AUXILIARY SENDER FRAME
EQUIPMENT DESIGN REQUIREMENTS
NO. 1 CROSSBAR AND PANEL SYSTEMS

1.001 This addendum supplements Sections 815-200-151, 816-500-150, Issue 6.

1.002 This addendum is issued:

Fig. 5—Relation of Circuits Within the Auxiliary Sender and Connections to other Circuits

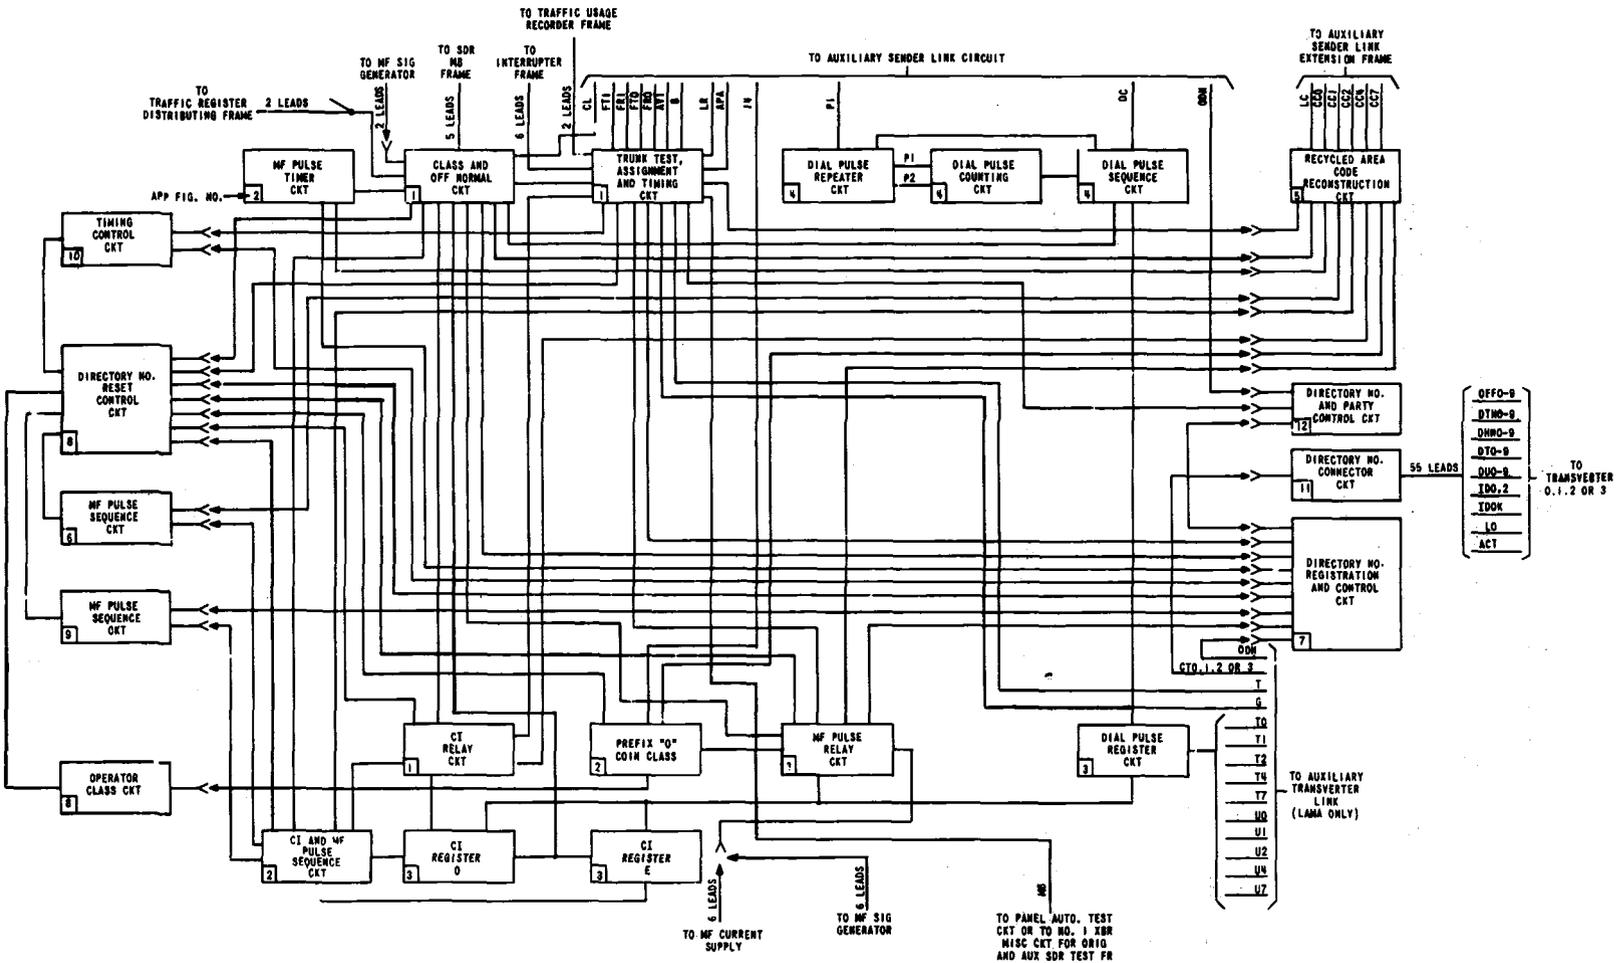
(b) To change Fig. 5 and 6 to reflect TV0, 1, 2, and 3; and add Fig. 10.

(a) Figures 5 and 6—Revised.
